IN THE CLAIMS:

REMARKS

FIG. 3

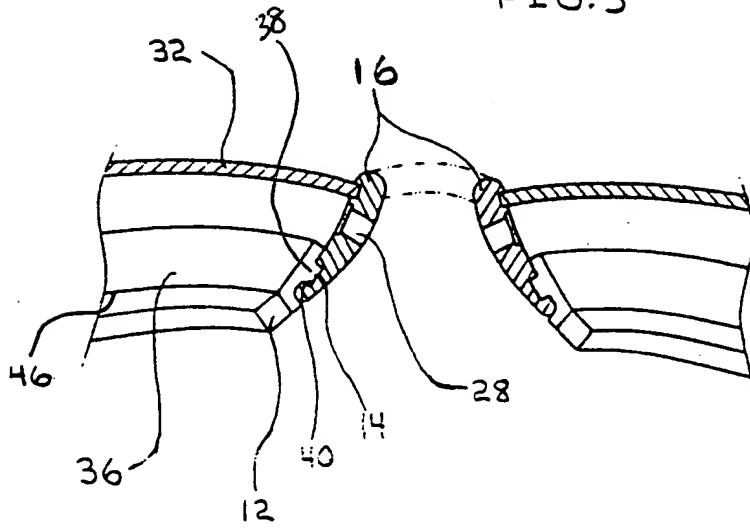
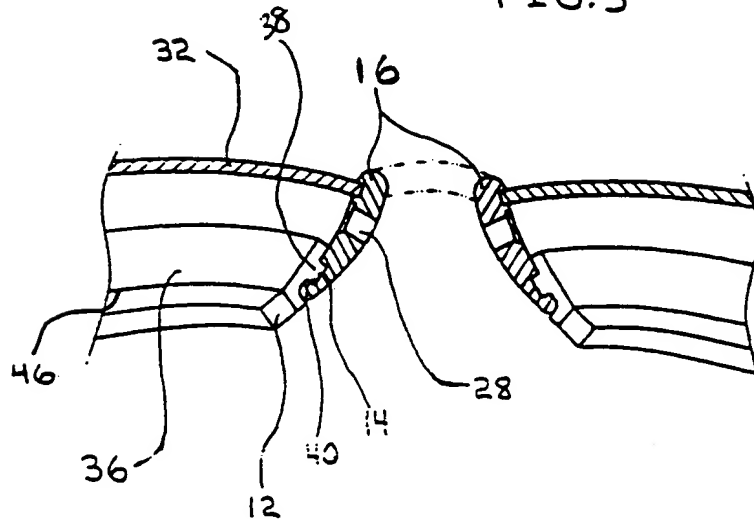
The drawings were objected for not showing a feature of claim 2, “the female portion accepts the male portion”.

Claims 2 and 14 were rejected for being indefinite since the feature of how the female portion accepts the male portion is unclear and the drawings do not show the interrelationship between the female portion and the male portion.

In response, Fig. 3 was amended to include reference numeral 38. Fig. 3 shows that the female portion 40 accepts male portion 38 when the inner frame 36 is attached to the eyeglass frame 16. In addition, Figs. 1 and 4 show the male portions 38, 38', and Figs. 1 and 5 show the female portion 40, 40' before the inner frame 36 is attached to the eyeglass frame 16. Therefore, the drawings clearly show the feature.

In response, Fig. 3 was amended as explained above. The drawings now show the interrelationship between the female portion and the male portion clearly. The feature of how the female portion accepts the male portion is described on lines 7 – 13 and 21 - 23, page 8 of the original specification. As disclosed in the specification, the detents 14, 14' include a male portion 38, 38' and a female portion 40, 40'; and the female portion 40, 40' is an indentation located on the nostril bridge support 26, and the male portion 38, 38' is a projection situated on the inner frame 36. It can be clearly understood from the specification and drawings that the female portion 40, 40' accepts the male portion 38,

38' by inserting the projection into the indentation for securely attaching the inner frame 36 to the eyeglass frame 16.
